PUBLIC HEARING MEMORANDUM

SUBJECT: **Petition #147-15**, BSL NEWTON DEVELOPMENT, LLC/ANDOVER NEWTON THEOLOGICAL SCHOOL, petition for SPECIAL PERMIT/SITE PLAN APPROVAL and EXTENSION of a NONCONFORMING STRUCTURE to renovate the top two floors of an existing dormitory (Farwell Hall) to include 12 reconfigured dormitory rooms and to use the bottom three floors and a proposed new attached structure for a 51-unit assisted living facility and to waive 28 parking stalls and various dimensional requirements of Sec 30-19 at **157 Herrick Road**, Ward 6, on land known as SBL 65, 19, 45, containing approximately 871,960 square feet of land in a district zoned SINGLE RESIDENCE 3. Ref: Sec 30-24, 30-23, 30-21(b), 30-9(b)(2), 30-5(b)(2), 30-19(d)(4), (d)(5), (h)(1), (2)(a) and b), (h)(3), (h)(4), (i)(1), (j)(1), (k), and (m) of the City of Newton Rev Zoning Ord, 2012.

157 Herrick Road

Figure 1 Pedestrians Crossing Herrick Road at end of Hebrew College Driveway

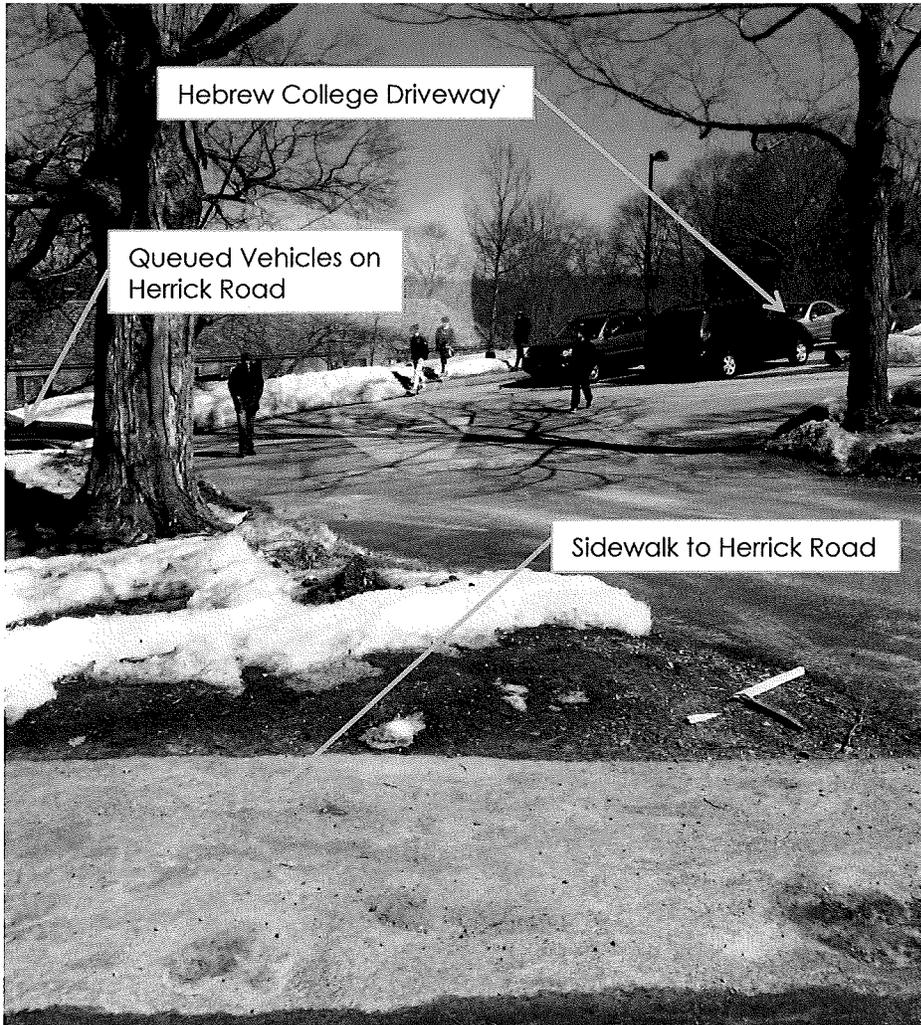
The Sunday afternoon peak volume is lower than the morning peak hour volume, but the impact is greater because of the intensity of traffic exiting the site during 15 minutes. From 1:30 to 1:45 PM, over 70 percent of the peak hour exiting traffic departs from the site. While the entering traffic is more evenly spaced out over the course of the hour, it is still more intense between 1:15 and 1:45 PM with 66 percent of traffic entering the site arriving during that 30-minute period. The result is queuing along Herrick Road starting around 1:25 PM and lasting until 1:35 PM. The queue down Herrick Road reached a maximum of nine vehicles at 1:33 PM. Some vehicles passed the queue and continued into the ANTS site and looped around, as there is additional stacking available within the site. This passing creates a potential conflict if vehicles are exiting the ANTS site at the same time since the vehicles passing the queue are driving in the path of the exiting vehicles. Additionally, the pedestrians (students leaving the Hebrew College) crossing Herrick Road at the end of the college driveway (directly across from the Herrick Circle, where site traffic would be exiting) were observed weaving in and out of the queued vehicles and vehicles exiting the Hebrew College driveway. This situation is shown below in Figure 1.

Although this is an existing condition and more of an issue for the Hebrew College, providing a formal crosswalk for students to get from the end of the Hebrew College driveway across the street to the sidewalk on the west side of Herrick Road could provide a benefit to all users of the roadway, including the Benchmark users. A formal crosswalk would provide a space for the pedestrians to cross where they would be more visible to the vehicles waiting in the queue to enter the Hebrew College or those trying to exit.

As mitigation measures, shift changes and deliveries should be avoided during the Prozdor peak periods, specifically between 9:00 and 10:00 AM and 12:45 and 1:45 PM on Sundays. Guests of the memory care facility should also be informed of the Prozdor peaks and the associated congestion near the Hebrew College driveway so they can schedule visits around these times. In addition to those measures, a crosswalk connecting the Hebrew College driveway to the sidewalk on the western side of Herrick Road could be considered as mitigation. While it will mainly benefit the Hebrew College students, it will be a benefit to all roadway users (including Benchmark) at that intersection as it would provide a designated place for pedestrians to cross the roadway.

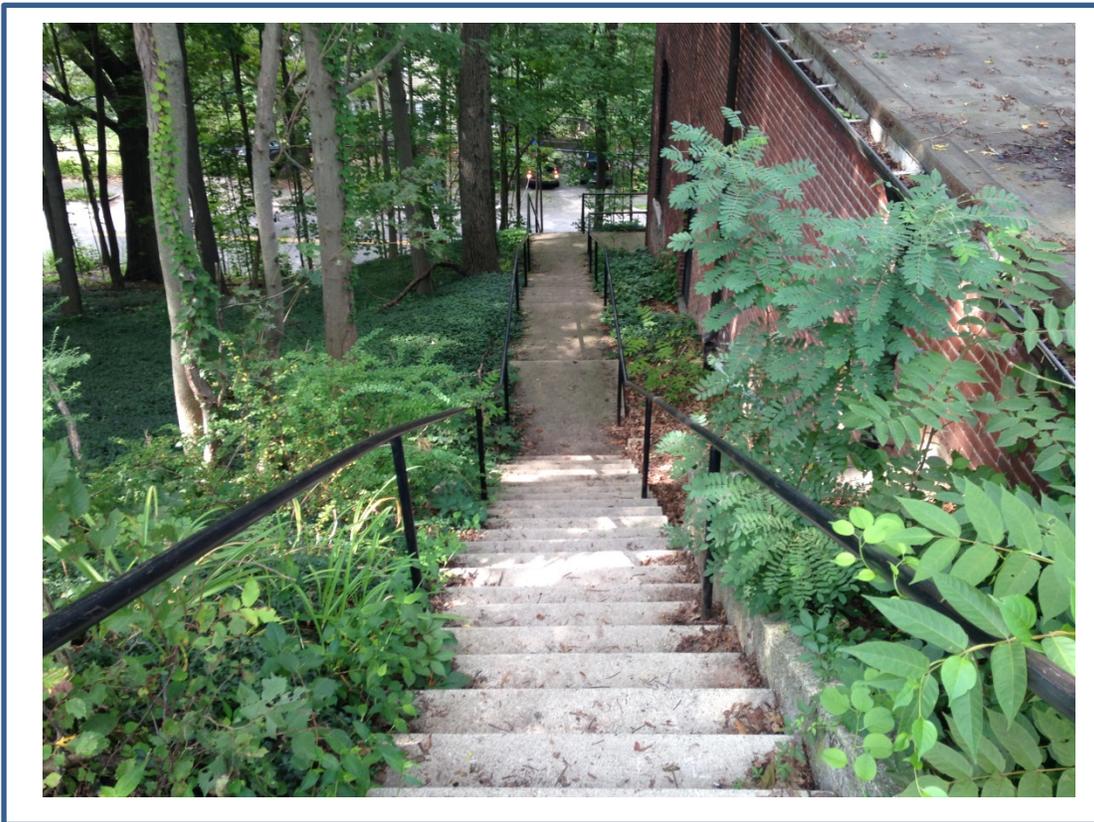
The plans also show a generic water service (the size needs to be indicated); furthermore, the building will require a dedicated fire suppression service connection separate from the domestic service. Siamese fire connection is also missing from the plan that the Fire Department will require. Furthermore, there is a concern for fire truck access and turning restriction from Herrick Circle onto the access driveway at the front of the building (see Sheet L-2.0) the curb line seems tight for fire apparatus maneuvering.
